July 27, 2012

FACILITY: LaSalle County Station, Units 1 and 2

SUBJECT: SUMMARY OF JUNE 28, 2012, PRE-APPLICATION MEETING WITH EXELON GENERATING COMPANY, LLC, TO DISCUSS LICENSING AMENDMENT REQUEST FOR LASALLE COUNTY STATION UNIT 1 AND UNIT 2 ULTIMATE HEAT SINK AT AT EXTENDED POWER UPRATE POWER LEVELS (TAC NOS. ME8866 AND ME8867)

Figure 3.7.3-1 (page 1 of 1)
Temperature of Cooling Water Supplied to the Plant from the CSCS Pond Versus Time of Day Requirements

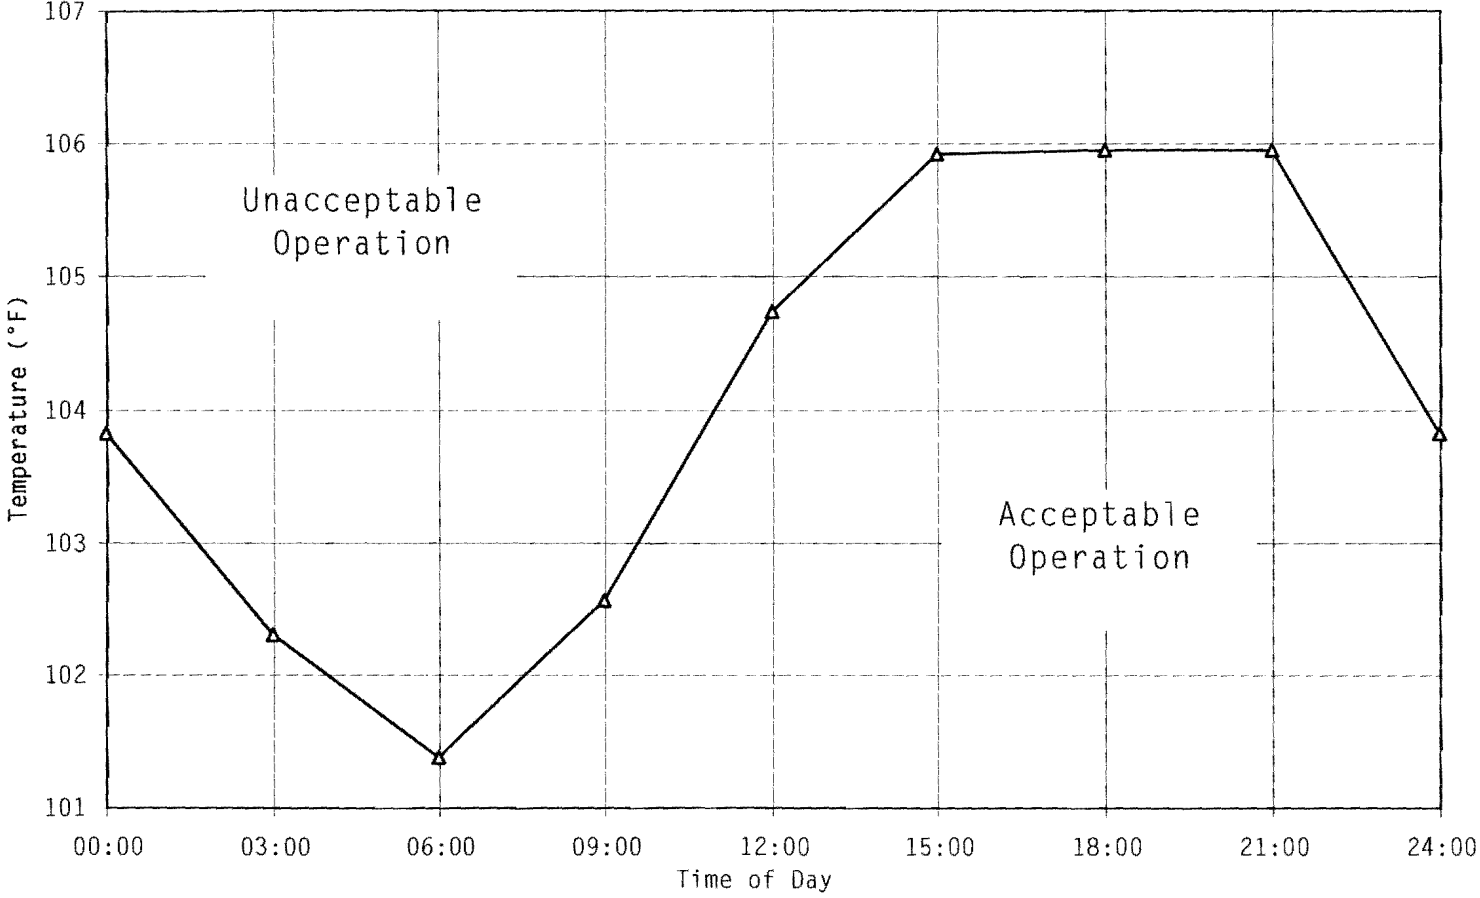
The licensee proposed a methodology that models the diurnal temperature cycle (temperature pattern that recurs daily) of the UHS heating and cooling. This approach is intended to utilize analytical margins traditionally apart of the existing linear UHS TS limit. The licensee stated that the UHS would remain conservatively below the proposed diurnal safety analysis limit of 107 °F. The staff expressed the following concerns with this proposed methodology. First, the staff questioned the analysis assumptions that only predict a 0.25 °F heat up for a design basis accident occurring at the proposed TS limit of approximately 106 °F at 3:00 p.m. Second, the NRC staff questioned whether in Enclosure 2 - Slide 16 indicated favorable weather condition for the 2nd and 3rd day of the accident. Third, the staff questioned how the licensee transitioned from the worst 24-hour period to the 2nd day of the analysis. Fourth, the staff requested that the licensee provide in their submittal the weather conditions by the hour for the first 72 hours following the accident. Fifth, given the significant number of important analysis assumptions the staff requested that the licensee describe and justify these assumptions in detail in their license submittal.
